Description of Work/Use: SIGN INSTALLATION INSTALL 2 WALL SIGNS FOR FIVE BELOW.
WAS LANE BRYANT STORE NOW TO BE FIVE BELOW STORE.

Install (2) wall signs for Five Below per the attached plans.

FB # 319 (Bricktown Plaza)

Sheet 4 of 4
ME #10-18301
4/20/2010

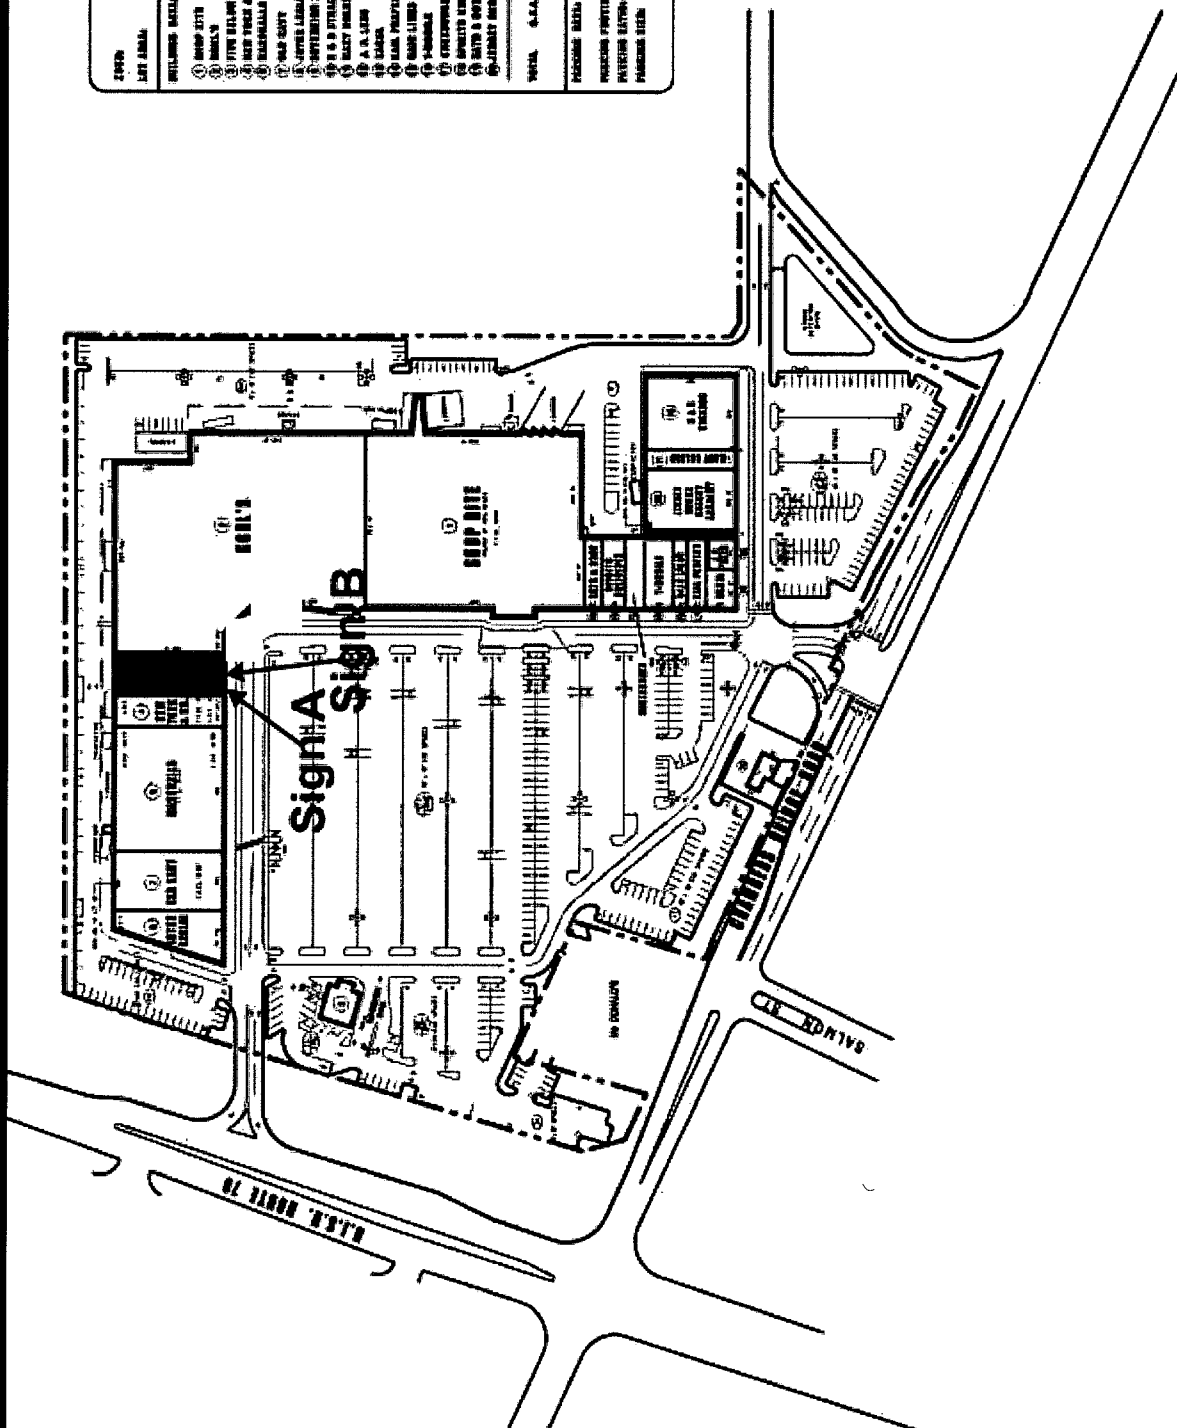
The following comments were made during the Plan Review process:
 Sign attachment details to be designed by a NJ Professional engineer or architect.
 Wind speed design of minimum 115mph, must be shown on plans.

Total Connections - Sign A (Letters) - Use (4) #12 Sheet Metal Screws to Attach Letters to Sign Panel. Use (3) #12 Sheet Metal Screws to Attach Letters I and O to Sign Panel. Sign B (Cabinet) - Use (24) #12 Sheet Metal Screws to Attach Cabinet to Sign Panel. Attach Sign Panel to Wall with (56) 1/2" Dia. Toggles OR 3/8" Dia. Lags into Min. 5/8" Thick Plywood. Space All Connectors Evenly. Screw Letter Trimcap or Retainer @ 6" O.C. Max.
